**ROSEVILLE**  
**REQUEST FOR COUNCIL ACTION**

Item Description: Request by Arthur Mueller, owner of the residential property at 2201 Acorn Road, for approval of a preliminary plat of the property into 4 lots

Preliminary Plat  
of  
OAK ACRES  
for  
Art Mueller

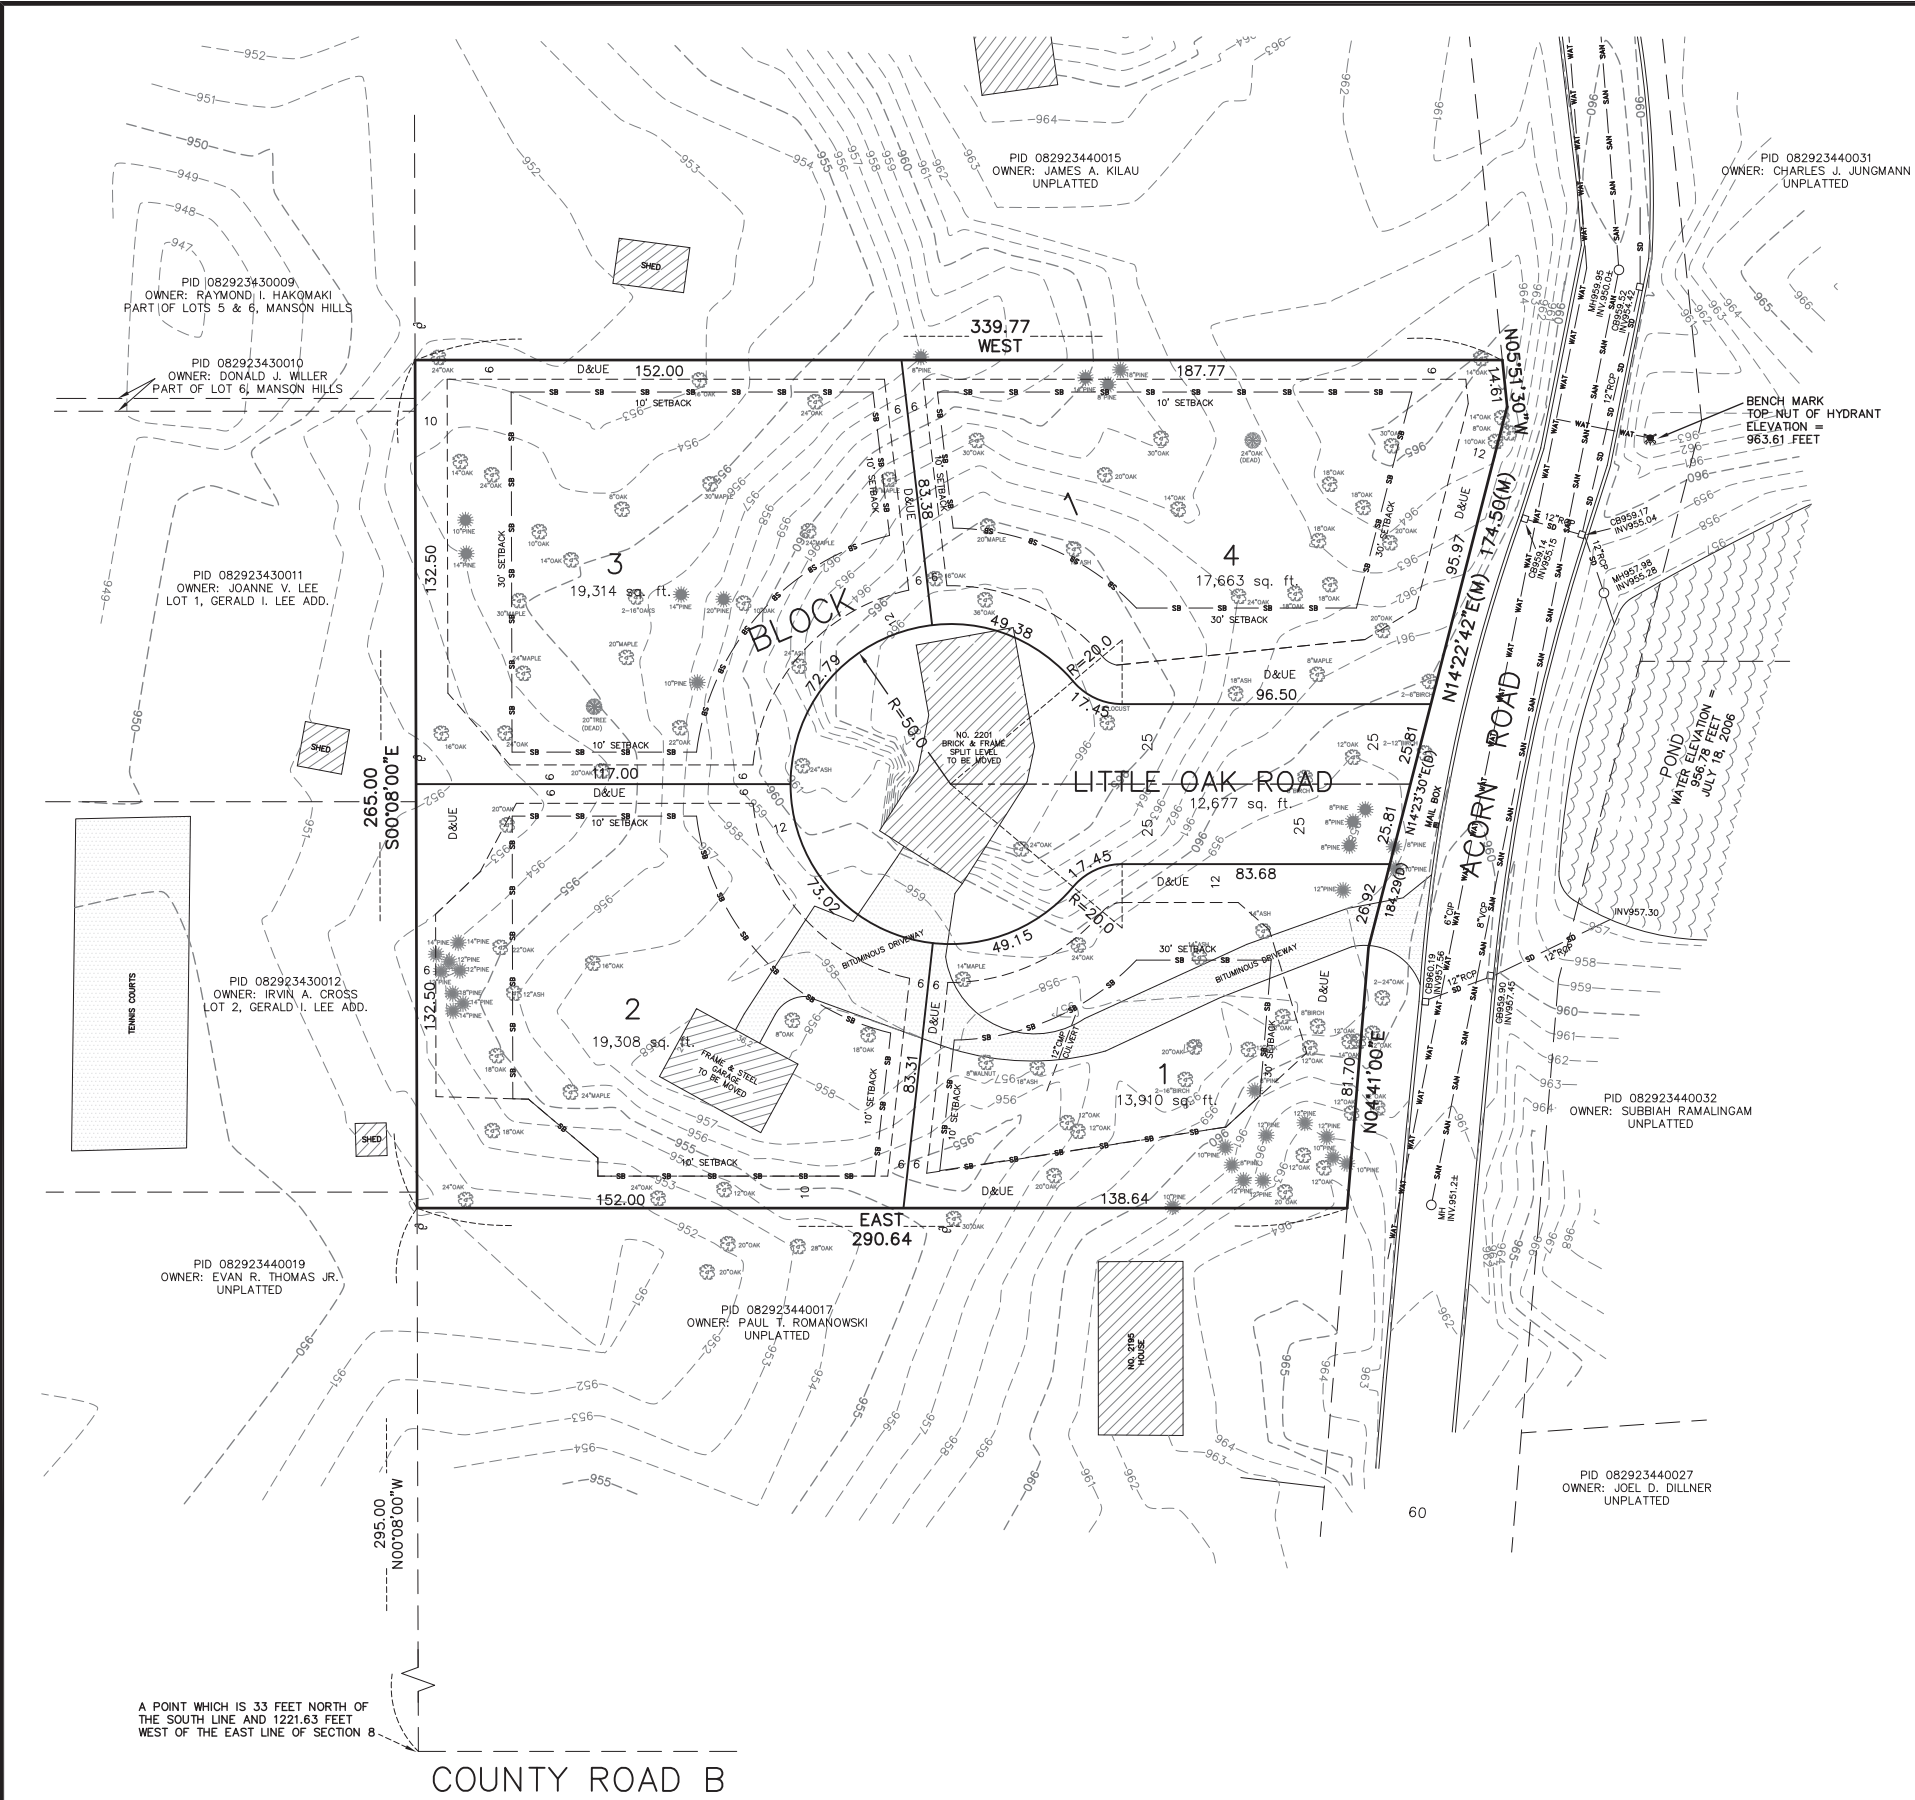
**a. City Code §1103.02 (Streets)-§1103.021 (Minimum Roadway Standards):** Right-of-way for a local street as proposed is required to be at least 60 feet wide and right-of-way for a circular turnaround on a cul-de-sac street must have a radius of at least 60 feet. The proposed right-of-way does not adhere to these standards; rather, because the proposed street is so short and so limited in the amount of traffic it will need to handle, the Public Works Department is working with the applicant on a design with reduced pavement width in a smaller-than-standard right-of-way under a provision which allows for the specific review and approval of such an alternative design. The proposed street right-of-way is the same as was approved in 2007 and similar to several others around the community. A public improvement contract pertaining to the construction of the proposed cul-de-sac street, biofiltration facilities designed to treat storm water generated by the public street, and sewer and water infrastructure will be necessary and should be required as a condition of PRELIMINARY PLAT approval.

**b. City Code §1103.04 (Easements):** Drainage and utility easements 12 feet in width, centered on side and rear property lines are required; the easements shown on the preliminary plat drawing meet these requirements. Additional easement area is shown coinciding with the proposed storm water retention/infiltration areas, known as “best management practices” or BMPs. The storm water plan exceeds the performance

**c. City Code §1103.06 (Lot Standards):** Corner lots must be at least 100 feet in width and depth and comprise at least 12,500 square feet of area, and interior lots must be at least 85 feet wide, 110 feet deep and comprise at least 11,000 square feet in area. All of the proposed lots exceed the applicable minimum standards.

159 Mr. LeTendre stated that he was interested in that information as well. Mr. LeTendre also noted ponds # 6  
160 and 4.b show that they would overflow onto neighboring properties; and questioned if the Commission  
161 had addressed that or not with the City Council; however, he opined that such a design or circumstance  
162 would not be upheld in court. If the Commission approved this proposal, Mr. LeTendre asked that they  
163 make it a contingency that no water from the development's ponding overflows onto neighboring  
164 properties.

In respect to the question related to overflow of two infiltration basins on the west side of the property, Mr. Culver noted that it did show potential overflows onto adjacent parcels. While unable to address what would be held up in court, from his standpoint, Mr. Culver advised that overflow basins were designed to withhold water for certain 100 year rainfall events – 7 inches over a 24-hour period, in excess of that, they would overflow into existing drainage patterns existing today. Mr. Culver advised that staff contends that the plan shown provides a reduction in overall drainage to the area, in essence capturing more stormwater than today; and as indicated by Mr. Lloyd, improved previous requirements slightly.

a. The applicant shall satisfy Public Works Department pertaining to easements, rights-of-way, grading and drainage, and public utility requirements, and other public infrastructure as necessary;

b. The applicant shall enter into a Public Improvement Contract pertaining to the construction of the proposed cul-de-sac street, biofiltration facilities, sewer and water infrastructure, grading and erosion, park dedication, and other essential items upon approval of the FINAL PLAT by the City Council; and
